Appendix B

Geotechnical Report

GEOTECHNICAL REVIEW SHEET

Date:	March 22, 2019	Review Log #:	3701
Site Address:	22959 Pacific Coast Highway		
Lot/Tract/PM #:	n/a	Planning #:	CDP 09-067
Applicant/Contact:	Joseph Lezama, joseph@buaia	BPC/GPC #:	
Contact Phone #:	310-456-5905	Fax#:	
Planner:	Adrian Fernandez		
Project Type:	Revised project: New three-level Malibu Inn Motel, grading, retaining walls with soldier piles and tie-backs, subterranean parking, new onsite wastewater treatment system (OWTS)

Enclosures: Geologic Map (In Pocket)
Cross Sections (In Pocket)
Geobrug SL Detail
Geotechnical Review Sheet by the City of Malibu

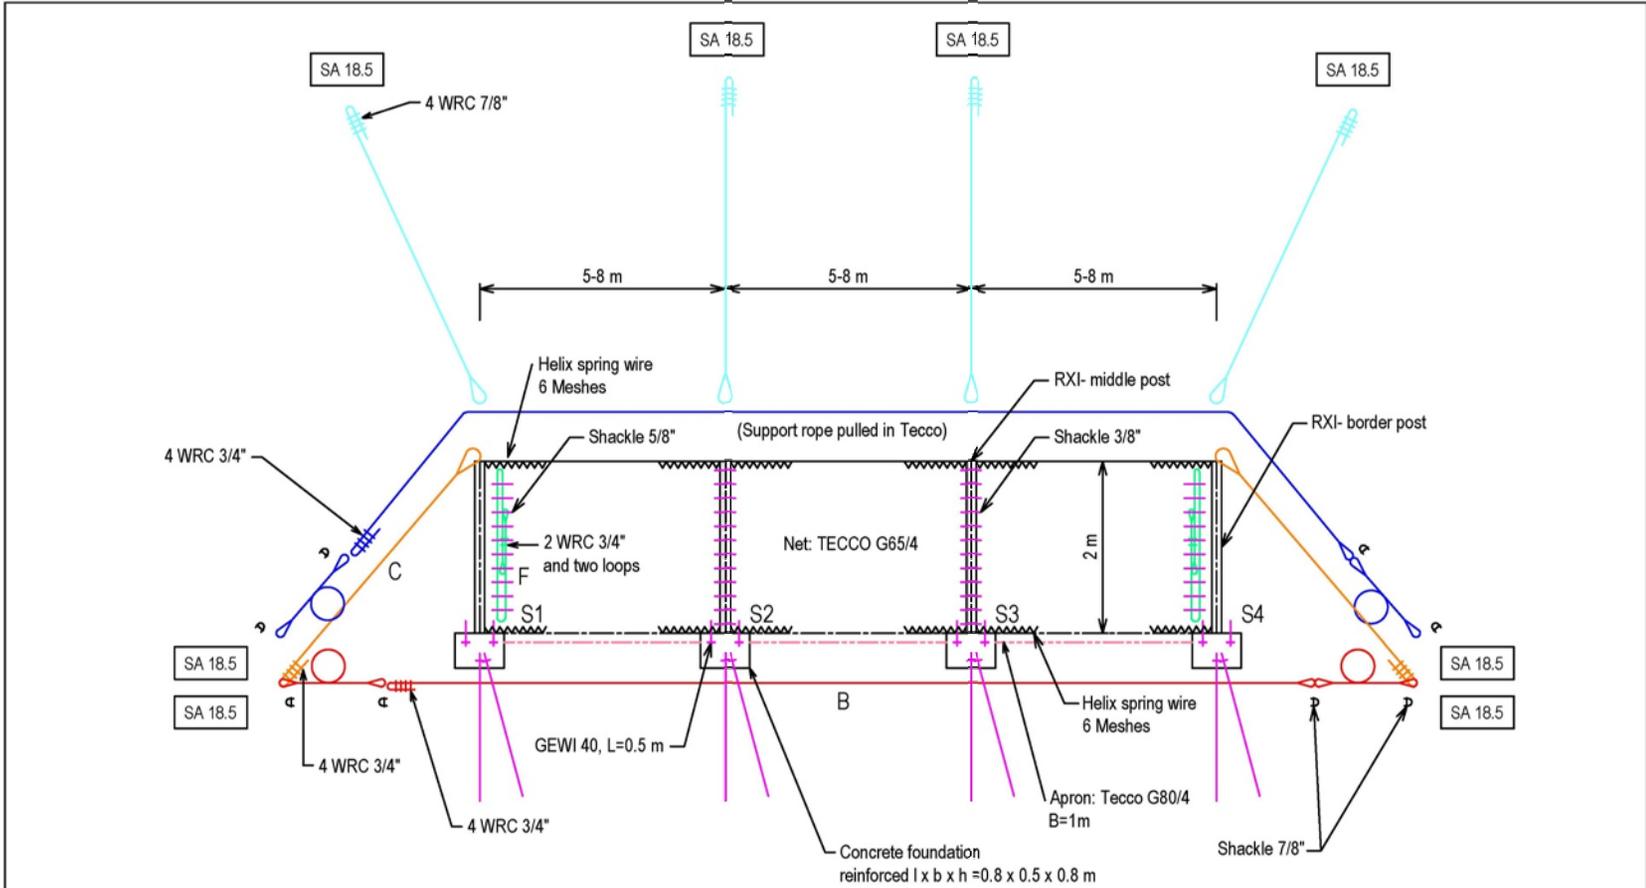
3. The proposed location and extent (vertical and horizontal) of the impact fence should be depicted on the grading plans and cross-sections. Specifications for the installation of the fence should be provided by the manufacturer and incorporated, as appropriate, with the project documents. Details of the fence installation at the eastern and western property lines should be designed and outlined to prevent debris deflecting into adjacent properties.

Item 1: The previous freeboard recommendation was four feet. Cross Sections A-A' and B-B' show four feet of freeboard on the retaining wall. The 15 foot slope setback is shown on the Cross Sections as well. In addition, a debris fence was recommended on the slope above the wall. The proposed debris fence is shown on the attached Geologic Map and on Cross Sections A-A' and B-B'. A detail for a Geobrug SL debris fence is attached.
